MEDIO CREEK WRC FILTER AND UV SYSTEM IMPROVEMENTS PROJECT

Solicitation Number: CO-00226

ADDENDUM 1

Date November 7, 2018

3 TYPICAL REINFORCED CONCRETE BEAM DETAILS

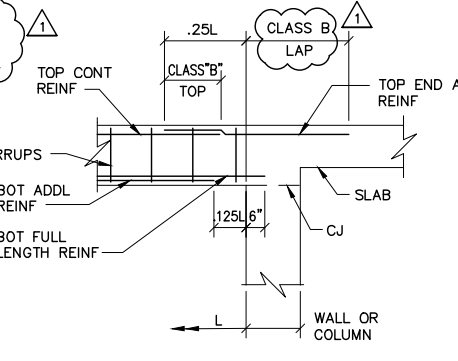
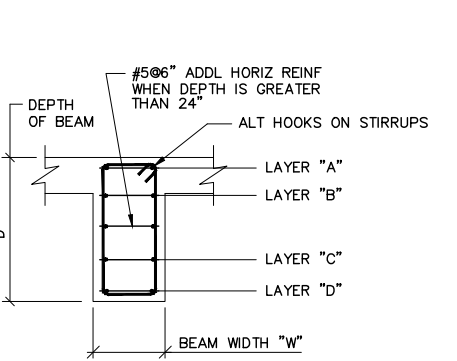
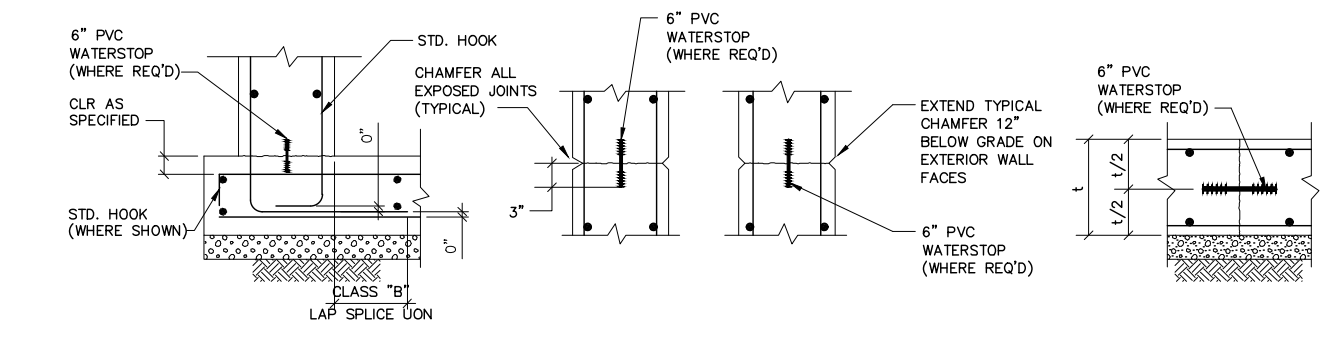
- a. Detail 3 updated to reduce the depth of the beam pocket.
